ECN/PCN No.: 1368

Product Description: Low Profile Shielded SMD Chip Power Inductor	Abrakon Part Number / Part Series: ASPI-0310FS Series	☐ Documentation only ☒ Series ☒ ECN ☐ Part Number(s) ☐ EOL
Affected Revision: E	New Revision: F	Application: ☐ Safety ☒ Non-Safety

Recommended Land Pattern

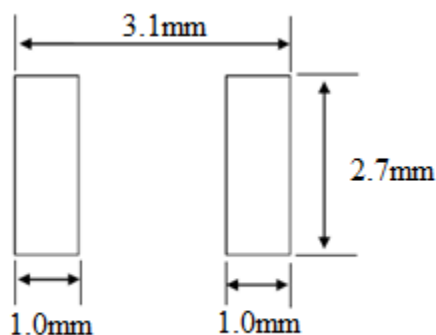
Moving to different production line. Uncovered erroneous pad dimensions in previous datasheet. Removed the -T2 suffix and replaced with -T.

Pad dimension correction may cause issues with existing designs. Ensure design engineer reviews pad dimensions in latest datasheet.
